UNITED STATES
NUCLEAR REGULATORY COMMISSION

Subject: COOPER NUCLEAR STATION - NRC SPECIAL INSPECTION
REPORT 05000298/2009008

Report: 05000298/2009008

IR 05000298/2009008; 02/23/09 – 05/12/09; Cooper Nuclear Station; Special Inspection into emergency diesel generator lubricating oil pipe cracking and Amphenol connector deficiencies

Figure 2: Comparison of Microstructure Evidence from the Emergency Diesel Generators 1 and 2 Lube Oil Pipe Crack fracture surfaces

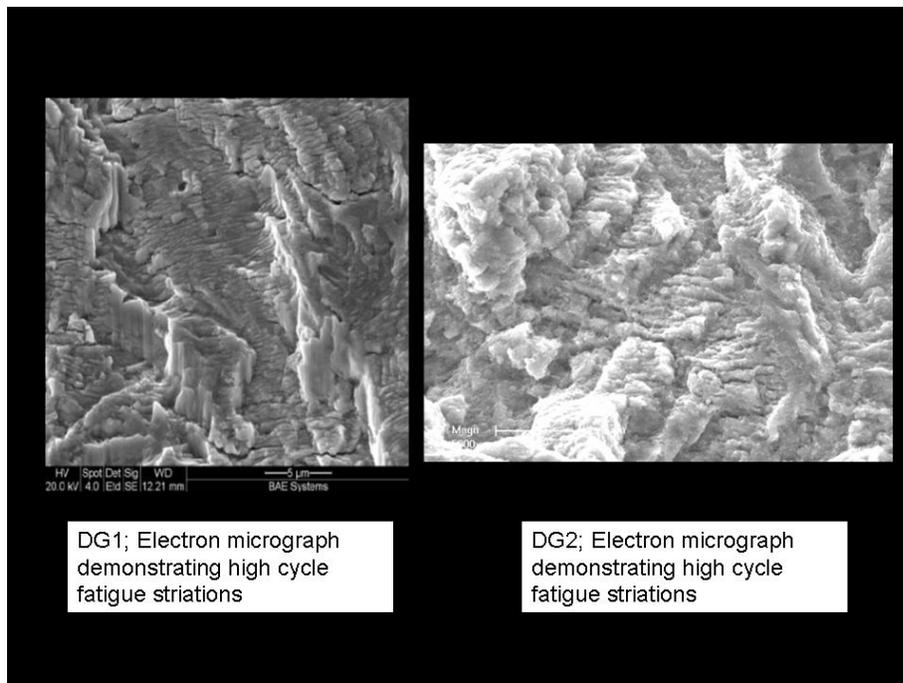
was flat and smooth with clear evidence of beachmarks and striations indicative of a high cycle fatigue failure mechanism (refer to Figure 2). The licensee initiated Condition Report 2009-00098 to resolve the NRC concerns related to misdiagnosis of the failure mechanism for the Emergency Diesel Generator 2 lubricating oil discharge S-pipe crack.

Figure 3 - Closeup of Magnetic Pickup Unit

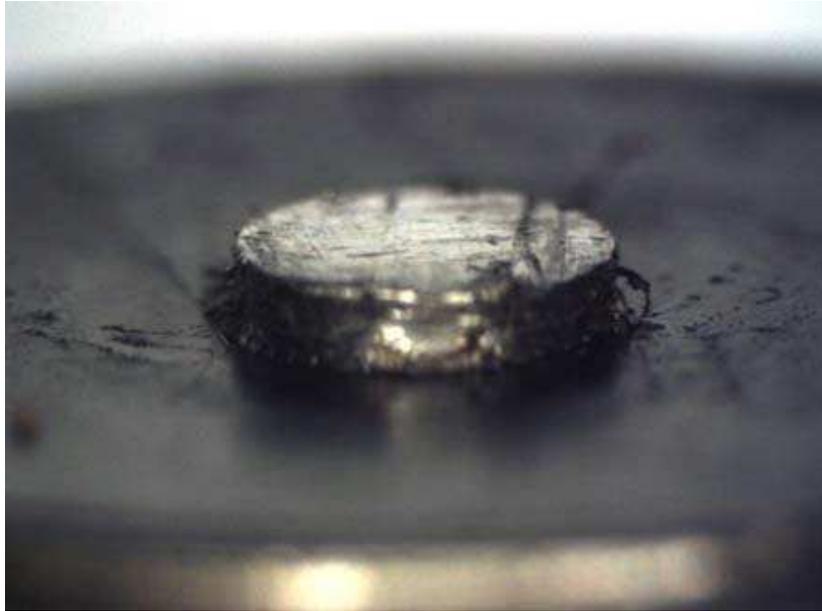
identified very minute metallic debris and rub marks on the probe (refer to Figure 3 in Attachment 6). The licensee determined the speed sensing gear impacts on the magnetic pickup unit probe produced the load swings observed during the April 20 and 21, 2008, tests. Since the licensee replaced the digital reference unit and magnetic pickup unit, verified the gap settings on the new magnetic pickup unit probe, and successfully completed operability and post maintenance tests without anomalies, the licensee concluded Emergency Diesel Generator 2 would perform its required safety function (refer to Figure 4 in Attachment 6).
